SOUTHERN GULF ISLANDS HARBOURS COMMISSION
Notice of Meeting on **Friday, October 9, 2026 at 9:30 am**
Saanich Peninsula Wastewater Treatment Plant Meeting Room,
9055 Mainwaring Road, North Saanich, BC

**REPORT TO SOUTHERN GULF ISLANDS HARBOURS COMMISSION
MEETING OF FRIDAY, OCTOBER 9, 2026**

SUBJECT **Southern Gulf Islands Harbours Projects and Operations Update – October 2026**

Southern Gulf Islands Harbours DOCK INSPECTION REPORT

Piers Island Dock Arrangement

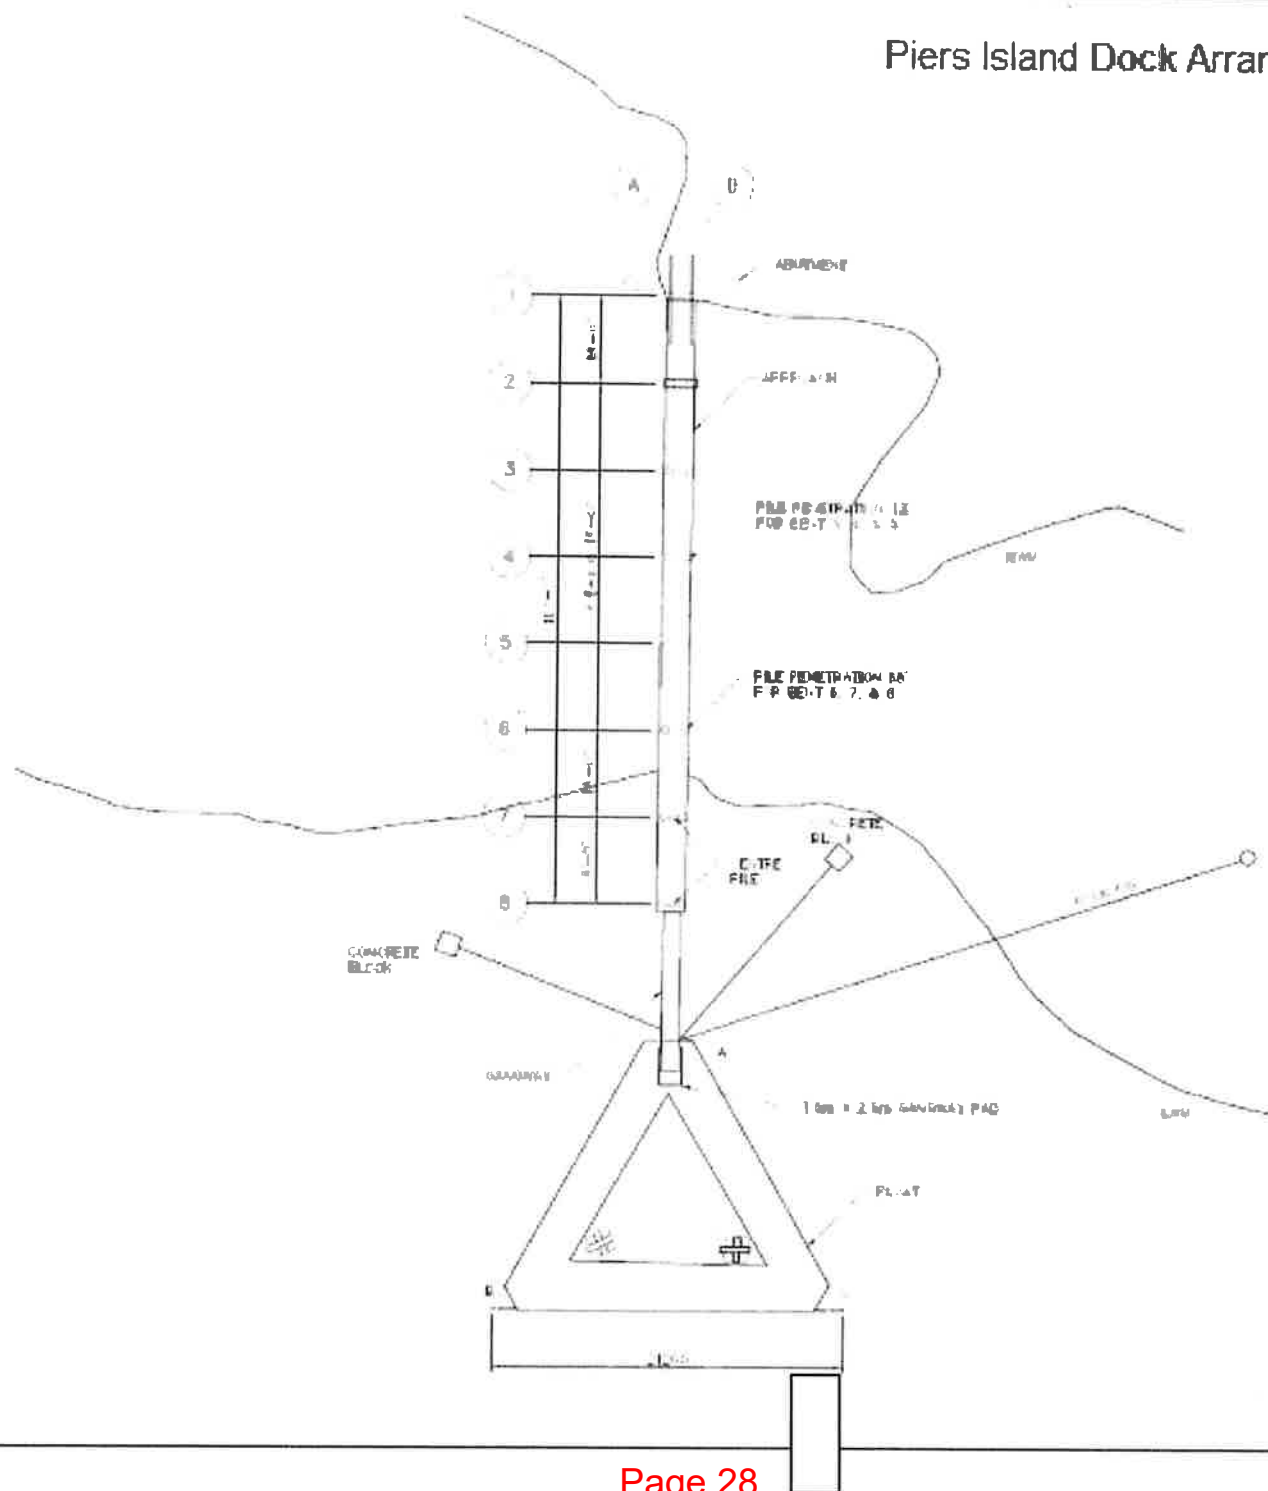
COMMENTS/INSTRUCTIONS	> Monitor for replacement, areas of developing rot on the main float or replace all decking with Mini Mesh decking. > Removal of the expanded metal grating on the main float is recommended.
------------------------------	---
